United States Department of the Interior

Re: Minor Modification of Resource Recovery and Protection Plan (R2P2), 4th Right Setup and Bleeder Location, Hiawatha Seam, Deer Creek Mine.

DEER CREEK MINE
4TH RIGHT SECTION
PROPOSED SETUP/BLEEDER ENTRIES

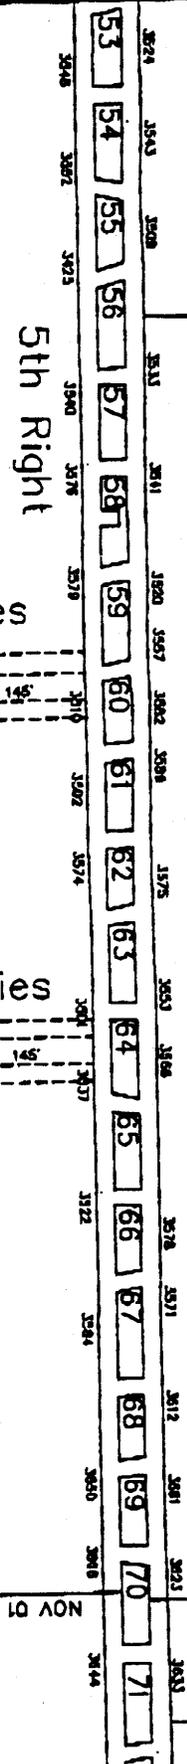
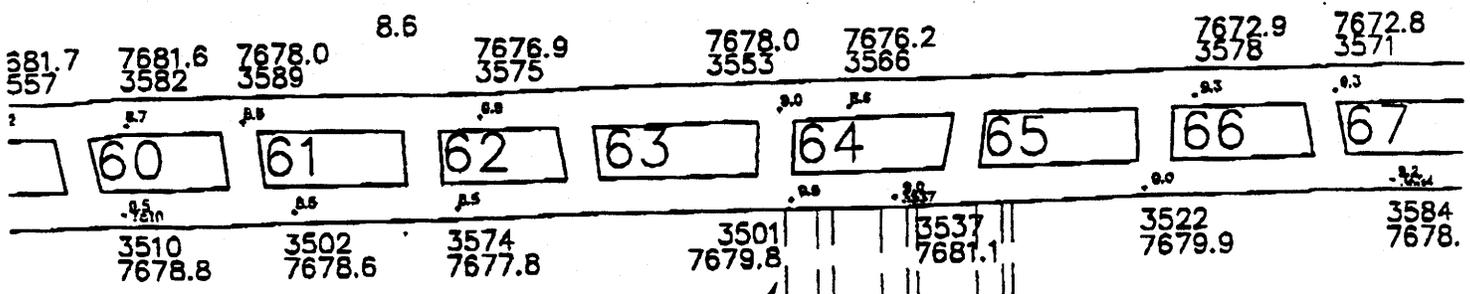
Interwest proposes to stop development of the 4th Right gate entries at crosscut 72 and mine new bleeder entries (possibly using these entries as longwall set up entries) between 4th and 5th Right at crosscut 68. In addition, an exploration entry would be mined 100 feet into the longwall block at crosscut 67 to verify conditions in the seam. Interwest reports that mining has encountered a system of sandstone channel features that has lowered the seam height from 9 feet down to 4 ½ feet at crosscut 72. Longwall mining through this area with a minimum 7 feet cutting height would result in unacceptable coal quality.

The BLM has inspected the area in question and witnessed the conditions. Coal seam height thins from 9 feet at crosscut 64 to 6 feet from crosscut 65 through crosscut 68. Height varies from 8 to 6 feet from crosscut 68 through 71, then thins dramatically to 4.5 feet just past crosscut 71. The trend of the channel system noted in the two entries of 4th Right indicates that the low coal extends to the north into the longwall block between 4th and 5th Right. The exact extent of the low coal into the longwall block is unknown as few indications were encountered in 5th Right. (Reference: Inspection Report SLF061902.)

The proposal has been evaluated by the BLM and we find it acceptable and logical. Further east development of 4th Right would force the cutting of 2 to 3 feet of rock with only 4 to 5 feet of coal with no assurance that the coal height would increase in any short distance east. Likewise, if the longwall were to mine through this block, the thin coal in the entries would undoubtedly extend for some distance into the block north and force the longwall to cut similar rock and coal horizons. Conservative estimates we have run show ash content of the coal well above 20 percent in this area. Should minable reserves exist east of this channel system, access is still available (as proposed by Interwest) through mining the next gate entry system, 3rd Right. Hence, Interwest's plan to mine the three entry bleeders at crosscut 68 and a 100 foot exploration entry at crosscut 67 is a logical attempt to bypass the channel system and prove out the coal thickness into the longwall block.

This letter confirms the verbal approval given on 26 June 2002, by our inspector to halt the 4th Right development and begin the bleeder entries at crosscut 68 along with the exploration entry at crosscut 67. Should the exploration entry show favorable conditions in the block, Interwest is approved to set and mine the 4th Right longwall at the setup/bleeder entries at crosscut 68. Please notify the Price Field Office if this is the result. Should the exploration entry show unfavorable conditions, we will need to check the conditions to approve the alternative setup entries at crosscut 64.

Adendum:
Proposed Option to
Submitted RRP2
MODIFICATION DATED
06/20/02!
 FIRST & LAST 50'
 CUT 28' WIDE
[Signature]
 06/26/02
